SUBJECT: Forwards response to Geosciences Branch 811201 questions.  
 Response include addl question & two amended questions. All  
 answers will be included in Amend 23 to FGAR.

Subject: NUCLEAR PROJECT NO. 2  
GEOSCIENCES BRANCH QUESTIONS

These responses will be included in Amendment 23 to the WNP-2 FSAR.

Project No. 14940	Hanford FSAR	LOCATION OF SLEMMONS' LINEAMENTS ON RATTLESNAKE HILLS, R25E, T11N	Figure 360.22-1
Woodward-Clyde Consultants

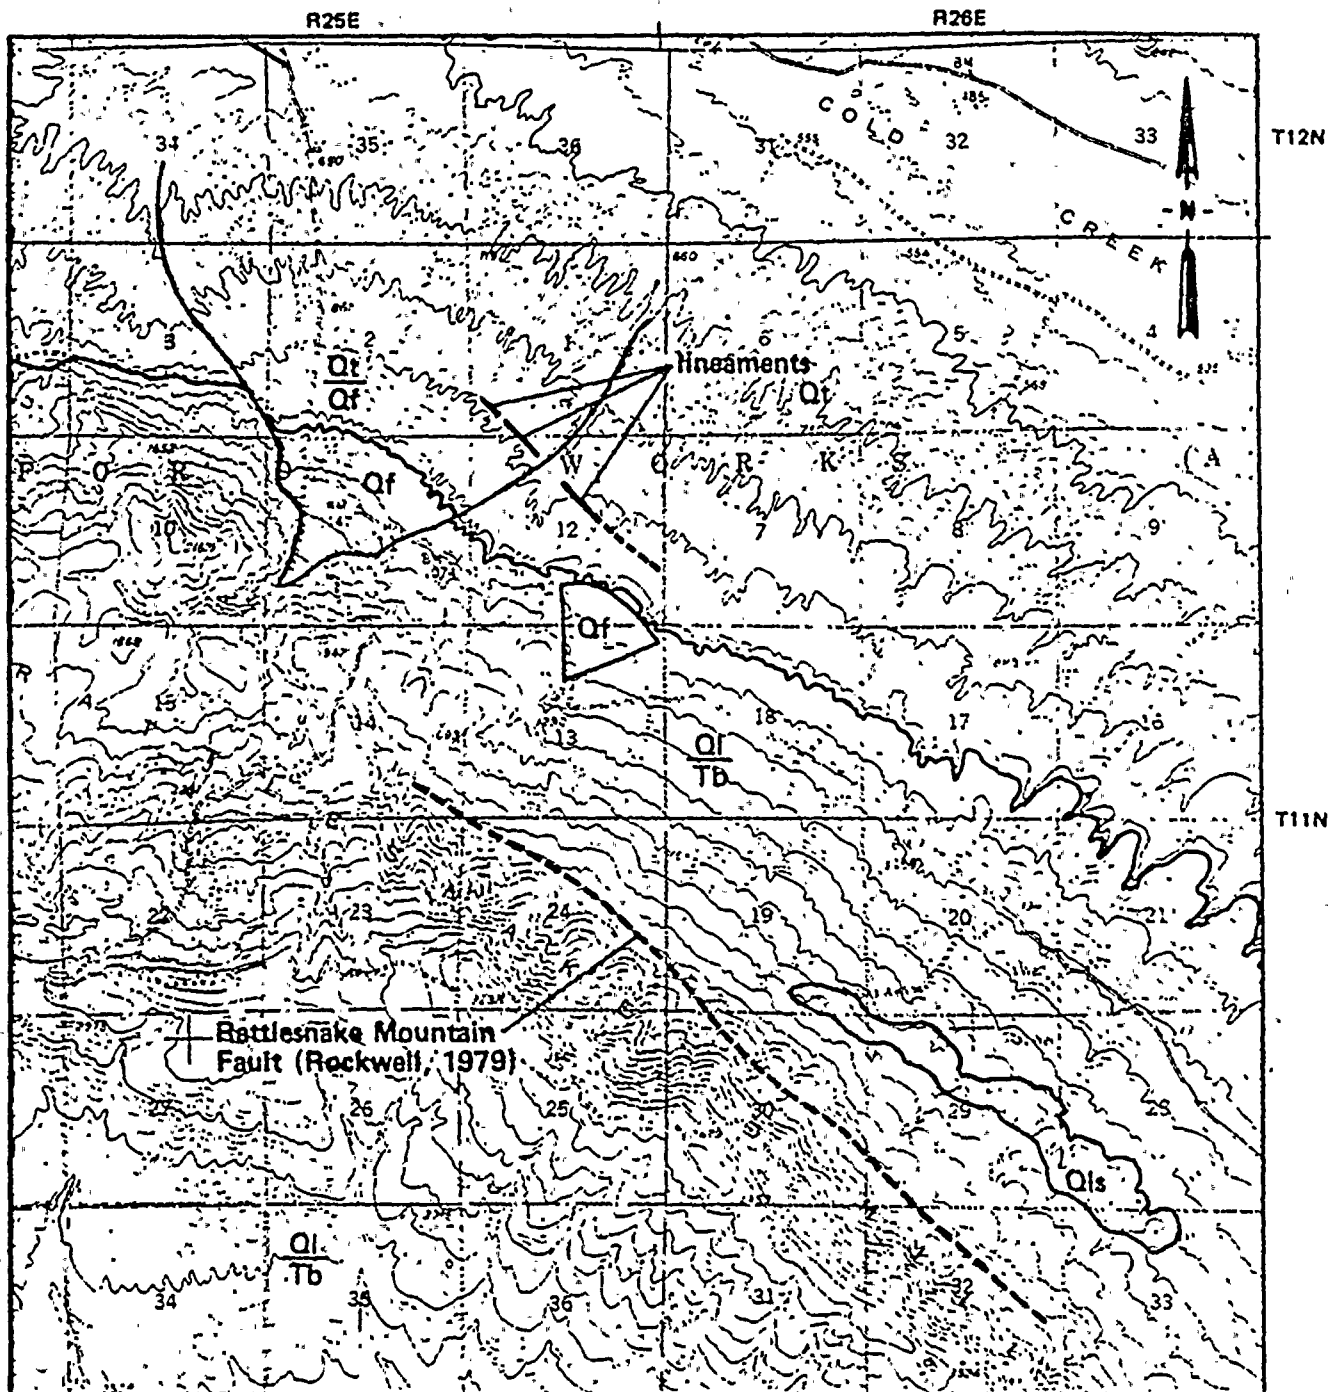
Provide a complete discussion of the linear feature located at about the 900 foot contour of Rattlesnake Hill (R. 25, T11N, Walla Walla 2° sheet), the extent of mapping in the area (provide map on topographic base), an assessment of its capability and, if applicable, maximum earthquake potential, including bases for conclusions.

The linear feature described in question 360.22 was reported by D.B. Slemmons during an aerial reconnaissance in early December, 1981. Dr. Slemmons described the feature as a series of back-facing scarps ranging from 1 to 3 feet in height trending from north-south to N20 - 30°W. The location was stated to be approximately one mile out from the range front on the alluvial fan whose apex lies approximately 5 km east of Snively Ranch (Section 11, R25E, T11N, Corral Canyon 15 minute quadrangle). The lineament occurs within sections 1 and 12 of R25E, T11N.

Detailed geologic mapping of the area that includes the lineament, was done by Shannon & Wilson (WNP-1/4 PSAR, Appendix 2R H, October 1977) but no such lineament is reported (op. cit., Figure 2RH.6-1). C.E. Glass undertook a remote sensing analysis (WNP-1/4 PSAR, Appendix 2RK, October 1977), but reported no lineaments within the alluvial fan described in Question 360.22.

white photographs (C.E.G. line 15A R-2, nos. 103 and 104; July 23, 1977) as a series of short discontinuous lineaments. The lineaments consist of an apparent alignment of short, relatively straight reaches of intermittent channels on, and adjacent to, the alluvial fan (see Figure 360.22-1). The trend of the lineaments is approximately N40W, approximately parallel to the axis of the Rattlesnake Mountain anticline. The overall length of the lineament defined by the aligned drainages is approximately 1.1 km. To the south, there is a linear tonal (vegetational) contrast on the color photographs that is about 0.5 km-long. If this is related to the aligned drainages, the total length of the lineament is approximately 1.6 km.

If the lineament is assumed to be the result of faulting, the implications to the assessment of the maximum earthquake magnitude depend on assumptions regarding the association of the lineament with the Rattlesnake Mountain fault. If the lineament is assumed to be a separate fault, its limited dimensions (total length 1.6 km) would indicate a maximum magnitude of less than 5-1/2 and is, therefore, insignificant to the site. If the lineament is assumed to be associated with the Rattlesnake Mountain fault the maximum magnitude assessment that was presented in response to Question 360.14 would apply. In that assessment, the Rattlesnake Mountain fault, is assumed to have a total length of 10 to 20 km, which significantly exceeds the length of the lineament. Therefore, the assumptions that the lineament is either a separate fault or a part of the Rattlesnake Mountain fault has no effect on the estimate of the maximum earthquake magnitude on Rattlesnake Mountain structure.

Figure  
361.16-1

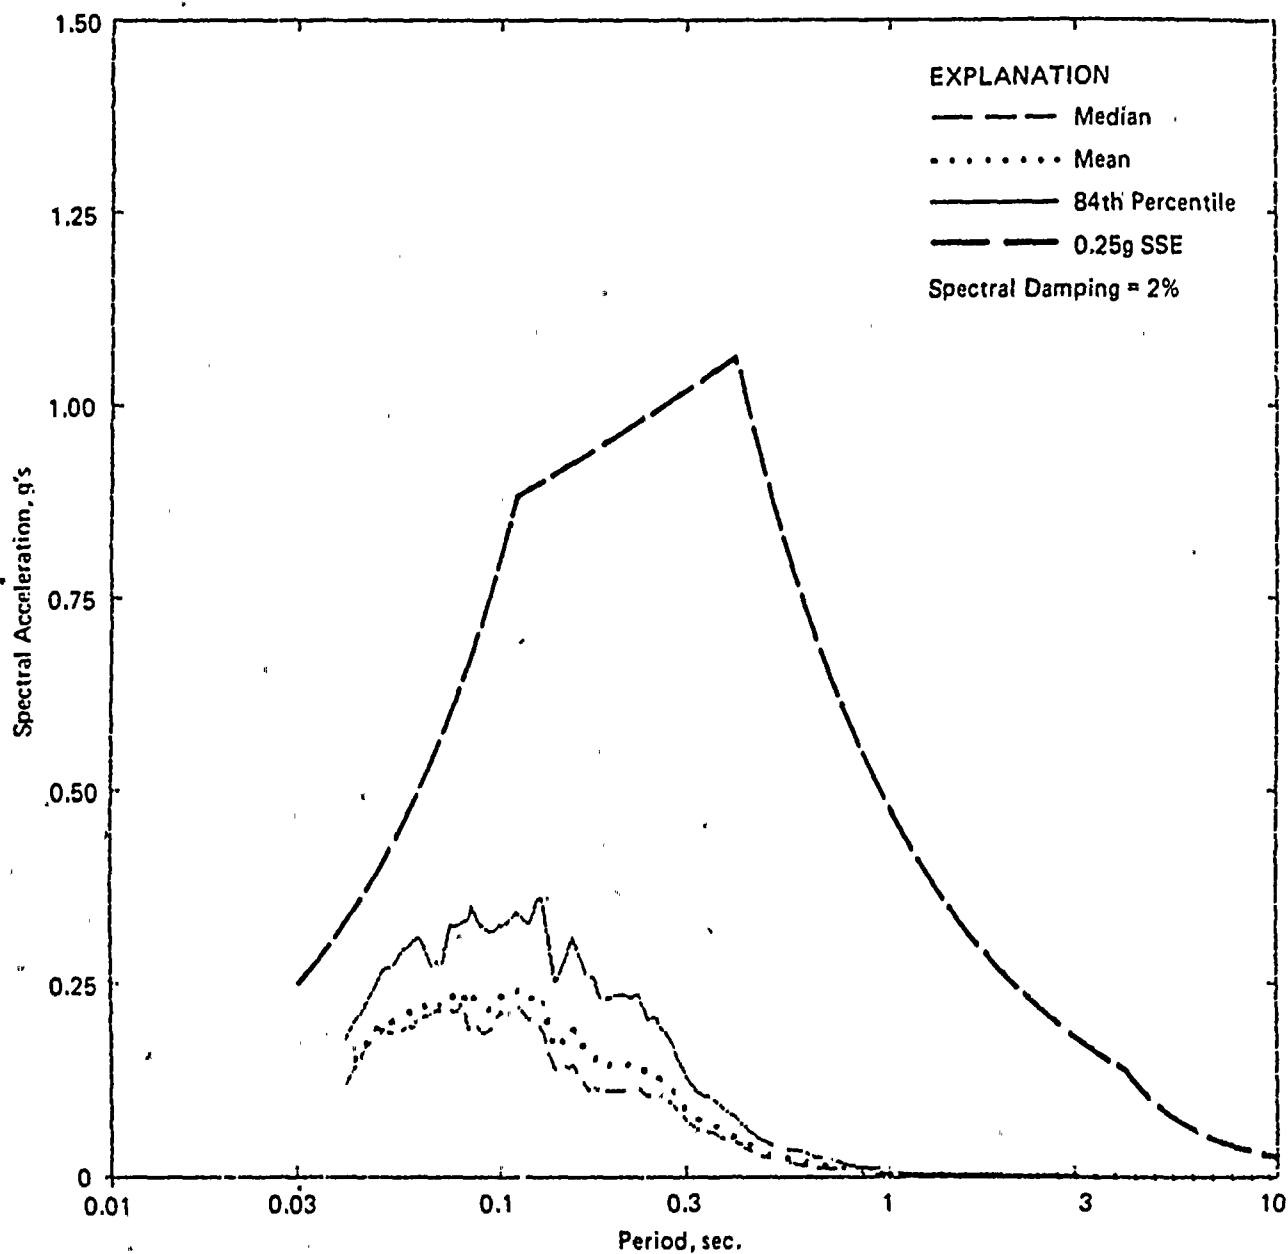
Estimate the ground motion (including high frequencies) assuming a magnitude  $M_L = 4.0$  (largest swarm event in the Columbia Plateau) occurred at a distance of 3 to 5 kilometers from the site. Compare the response spectra from this event to the SSE response spectra. Also, state your position on how large and close a potential swarm earthquake could come to the site.

Table 361.16-1 lists the 12 available accelerograms for magnitude  $M_L$  4.0 to 4.1 Oroville aftershocks in the distance range 8 to 13 km on soil sites. Two of the recordings were obtained at the Johnson's Ranch station, which has been shown to exhibit a significant "ringing" at a frequency of 6 Hz due to a 10-meter thick layer of alluvium overlying bedrock. Figure 361.16-1 show the median, mean and 84th percentile response spectra computed using the twelve recorded motions. Also shown is the 0.25 g-SSE design spectra (Regulatory Guide 1.60 spectra anchored to 0.25 g). (The WNP-2 plant has been analyzed and found to be adequate for the RG 1.60 spectra anchored to 0.25 g.) The statistical spectra are generally well below the design spectra, approaching the SSE only at high frequencies.

As can be seen in Figure 361.16-1, there is a large peak in the statistical spectra at a period of 0.17 seconds (frequency 6 Hz). The source of the peak is the recordings obtained at Johnson's Ranch. Figure 361.16-2 shows the effect of removing the four accelerograms obtained at Johnson's Ranch from the data set. The large peak at 6 Hz is removed and the over-all level of spectral acceleration is reduced.

Figure  
361.17-8

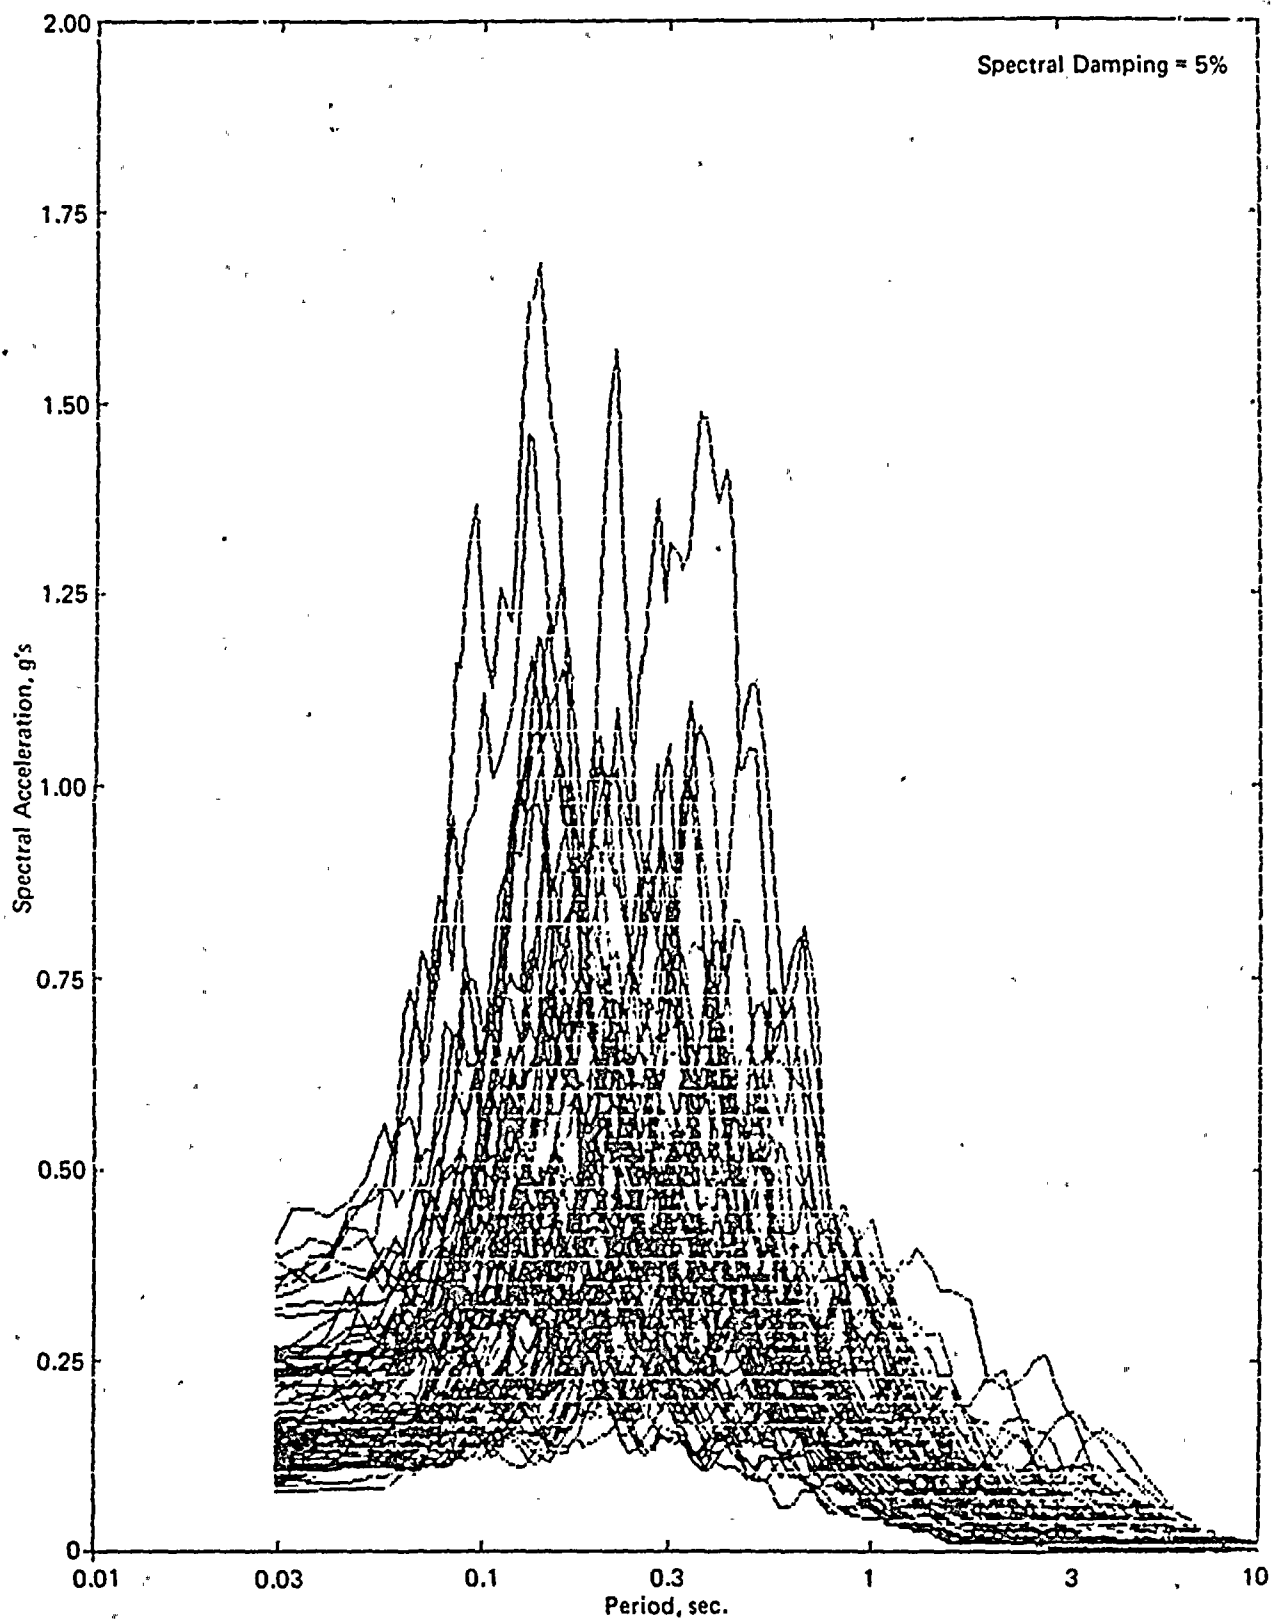
Estimate the ground motion (both peaks and response spectra) from an  $M_L$  6.1 (July 16, 1936) earthquake occurring close to the WNP 2 site. Compute the median, mean and mean plus one standard deviation from this data set and compare them with the SSE response spectra. Also provide the staff with a comparison of the site conditions of the chosen strong motion recordings and the WNP-2 site.

Figures 361.17-8 through 361.17-10 show an overplot of the 70 response spectra for 2%, 5%, and 7% spectral damping, respectively. The peak accelerations range from 0.08 g to 0.44 g. The large scatter in the peak accelerations and response spectra is due partly to the inherent variability in earthquake ground motion, and partly to the range in magnitudes and distances for the individual recordings.

FIGURE  
3.6-41a

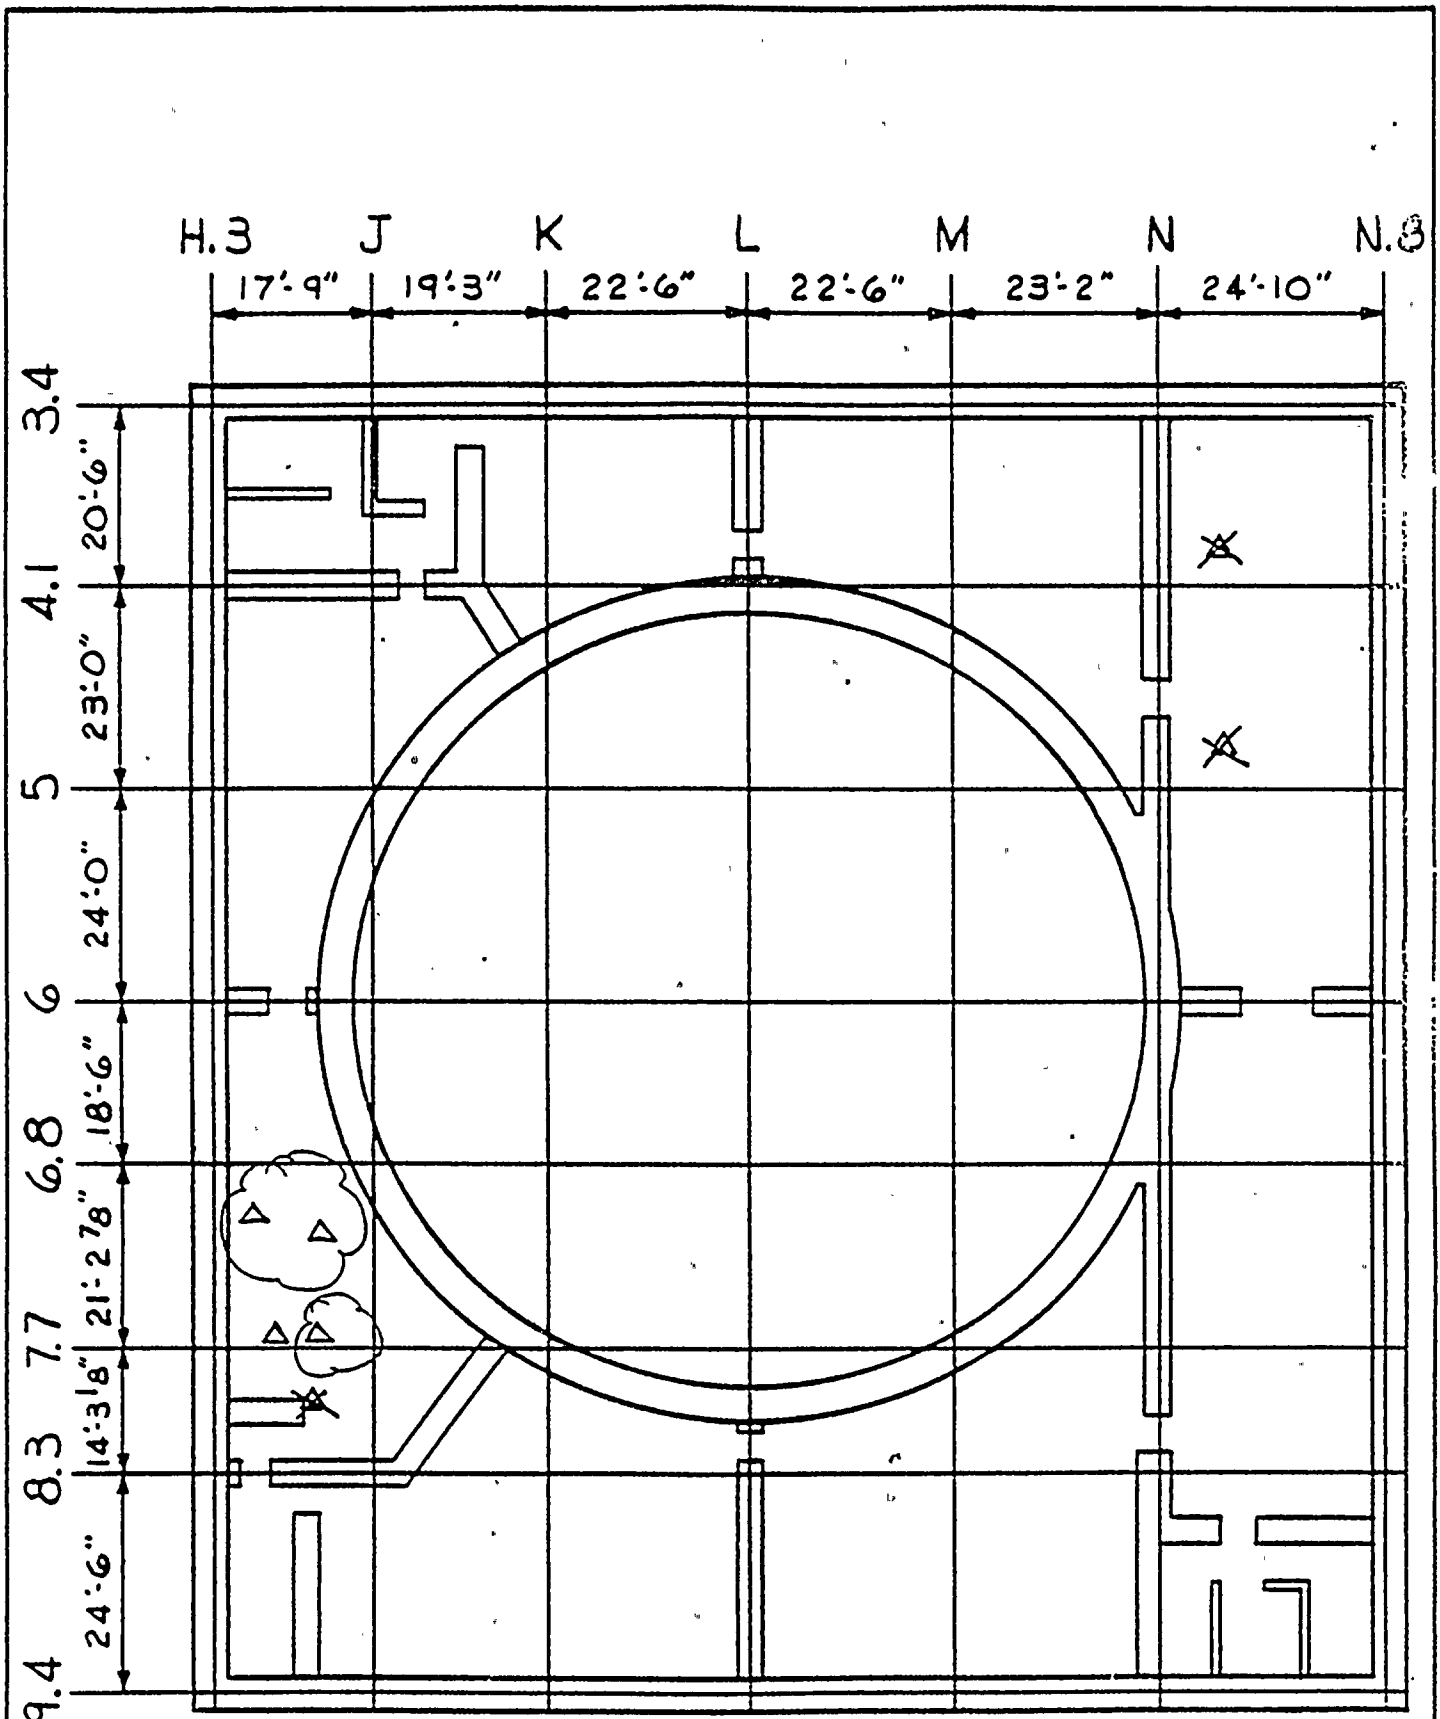
Revise as shown
